14 MARCH, 1995

BULLETIN.123

W34-0 WIREFEEDER

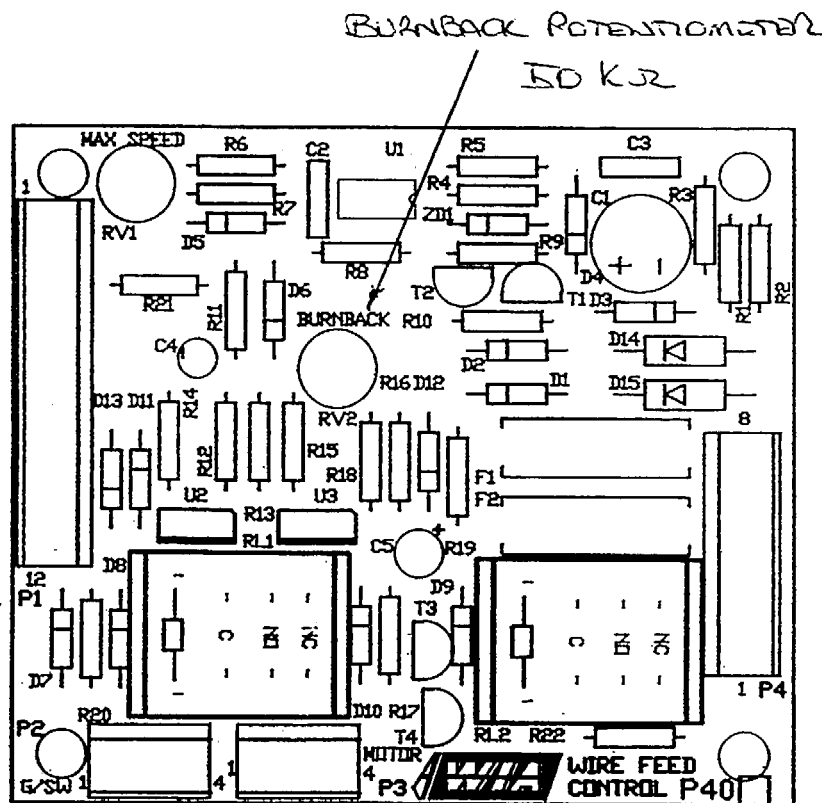
All W34-0 wirefeeders manufactured to date have been shipped without a burnback potentiometer fitted to the wirefeed control pcb. This results in very long burnback periods at end of weld.

The potentiometer required is a 50k trimpot, WIA part number W11-7/8. It should be installed in the vacant circuit position shown on the diagram below.
